# Proposed Road Development at Shannon Foynes Port

**Stage 1 Road Safety Audit**

<b>1.1</b>	<b>Title</b>	<b>RSA Shannon Foynes</b>
<b>1.2</b>	<b>Audit Reference Number</b>	<b>RSA SHANNON FOYNES S1 KS 275</b>
<b>1.3</b>	<b>Project Code</b>	<b>SHANNONFOY</b>
<b>1.4</b>	<b>Date Audit Completed</b>	<b>25<sup>th</sup> April 2018</b>
<b>1.5</b>	<b>Audit Team</b>	
	<b>Team Leader</b>	<b>Ken Swaby, ILTP</b>
	<b>Team Member</b>	<b>Mark Andrews, ILTP</b>

**Figure 3.1: Existing Priority Junction in Immediate Proximity to Proposed New Priority Junction** (Source: RPS drawing *Proposed Road Markings – Sheet 1 of 4*, ref: H0548-RPS-XX-00-DR-HE-110-02)

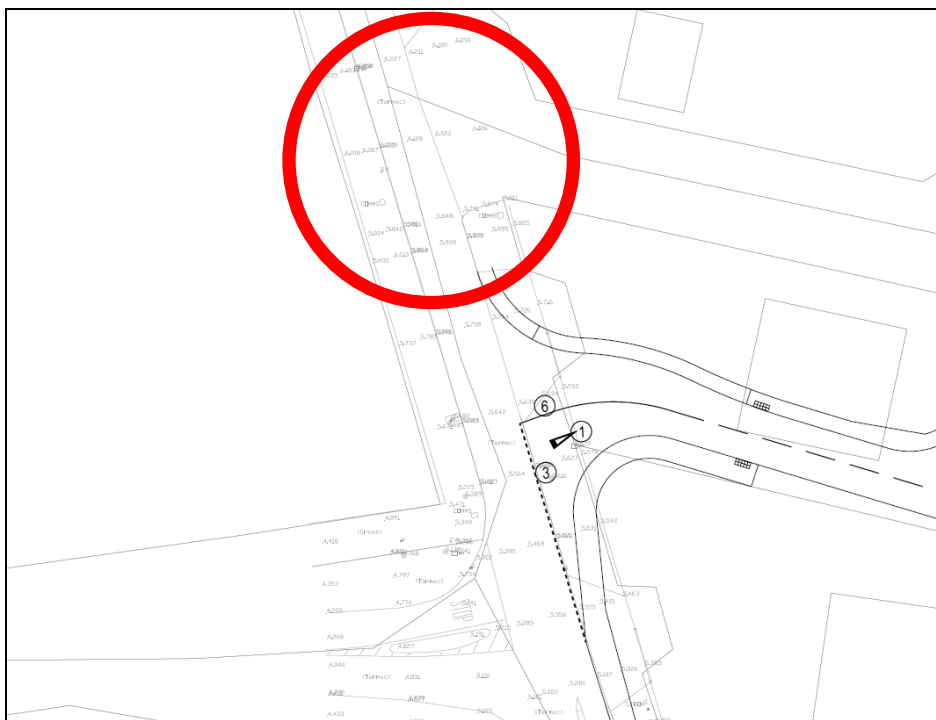
The information provided for audit does not indicate if the existing priority junction to the north of the proposed road works on the main port access road is to be retained, and do not show tie-in details for same (junction highlighted in Figure 3.1). The proposed new priority junction to the south is in the immediate proximity of this existing junction. In the event where both junctions are incorporated into the development, this presents a potential risk that traffic may emerge from either junction without appropriate knowledge of traffic at the other intersection. Such closely spaced intersections also present a potential risk of road users incorrectly interpreting the road layout in this area and / or inappropriately indicating the intended direction of travel and coming into conflict.

It is recommended that the design team clarifies the proposed nature and configuration of the existing junction to the north of the proposed new priority junction, and how it is to be incorporated into the wider scheme. It is further recommended that the design team considers closing this existing access to vehicular traffic.

**Figure 3.3: Proposed Uncontrolled Pedestrian Crossing in Vicinity of New Priority Junction on Main Port Access Road** (Source: RPS drawing *Proposed Road Markings – Sheet 1 of 4*, ref: H0548-RPS-XX-00-DR-HE-110-02)

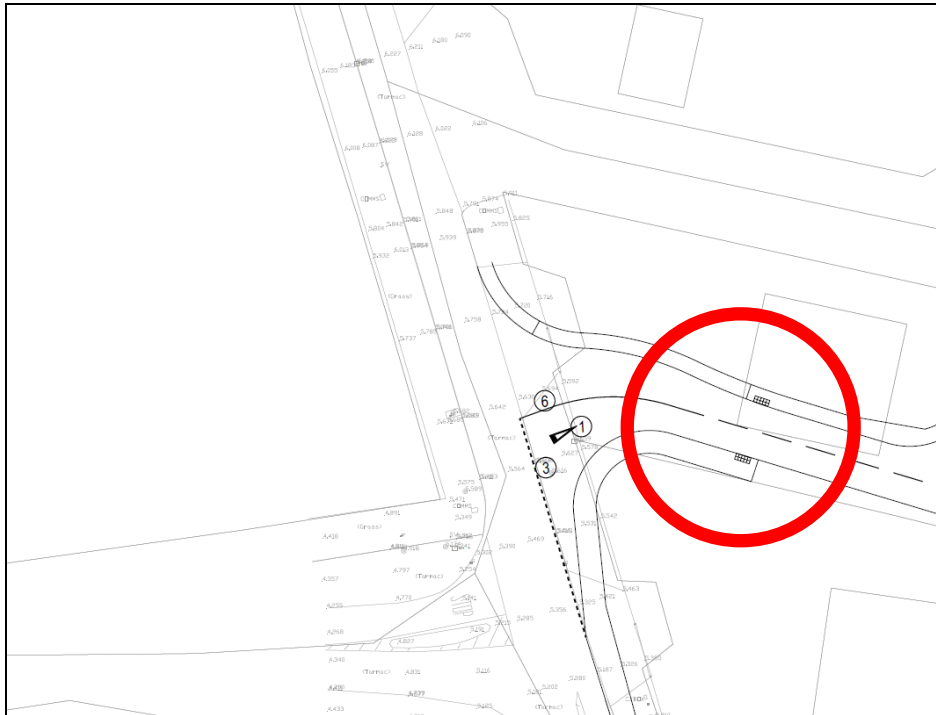
The pedestrian crossing located close to the proposed new priority junction on the main port access road (see Figure 3.3) appears to be well outside pedestrian desire lines for the majority of users and will potentially not be used by most pedestrians. This may potentially result in pedestrians or other non-motorised users crossing the carriageway at inappropriate locations and coming into conflict with passing traffic.

It is recommended that the design team ensures that there is appropriate continuity of pedestrian facilities at this junction along pedestrian desire lines.
